Access Compliance Report

Public Rights-of-Way

(Curb Ramps)

Intersection ID: N/A	Main Street: WALNUT_LOOP_RD	Cross Street: WOODBINE_WALK_RD	Location: SW
ADA ID: 95C43768E96C	Ramp Type: Perp	Initial Pass/Fail: Fail	Overall Compliance: No
Severity Score: 13.75			
Codes/Mitigation Info/Possible Solution		Field Measurements/Component Compliance

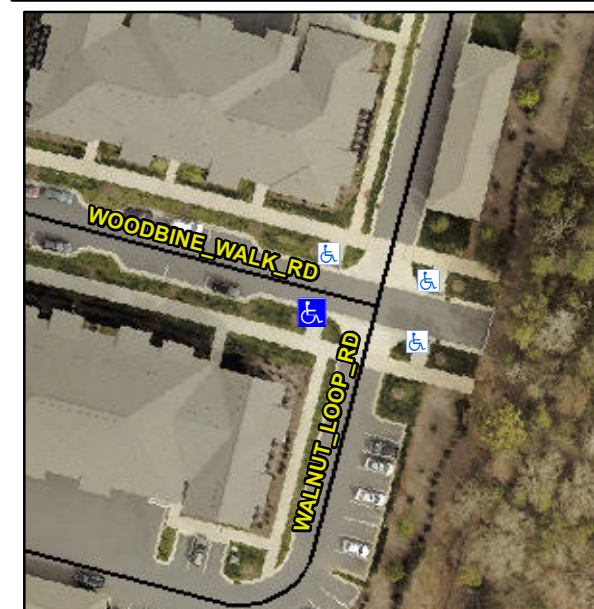
Not Found, R304.2.2, R304.5.3

Compliance	Description	Data	Compliance	Description	Data
N/A	Ramp Length (in)	72.0	No	Ramp Slope (%)	8.5
Yes	Ramp Width (in)	94.0	No	Ramp XSlope (%)	3.7
N/A	Flare Type LT	N/A	N/A	Flare Type RT	N/A
N/A	Flare Slope LT (%)	N/A	N/A	Flare Slope RT (%)	N/A
N/A	Flare Traversable LT?	N/A	N/A	Flare Traversable RT?	N/A
N/A	Landing Length (in)	N/A	N/A	DWS Provided?	N/A
N/A	Landing Width (in)	N/A	N/A	DWS Contrast?	N/A
N/A	Landing Slope (%)	N/A	N/A	DWS Length (in)	N/A
N/A	Landing X Slope (%)	N/A	N/A	DWS Full Width?	N/A
N/A	Landing Curb? (Y/N)	N/A	N/A	DWS Offset (in)	N/A
N/A	Shared Landing?	N/A			
N/A	Gutter Ponding?	N/A	N/A	Gutter Slope (%)	N/A
N/A	Gutter Lip Ht (in)	N/A	N/A	Gutter X Slope (%)	N/A
N/A	Painted X Walk1?	No	N/A	Painted X Walk2?	N/A
	X Walk 1 Direction	To NE		X Walk 2 Direction	N/A
N/A	X Walk 1 Width (in)	N/A	N/A	X Walk 2 Width (in)	N/A
	X Walk 1 Slope (%)	1.2		X Walk 2 Slope (%)	N/A
	X Walk 1 X Slope (%)	1.8		X Walk 2 X Slope (%)	N/A

Remove & Replace Entire Ramp.
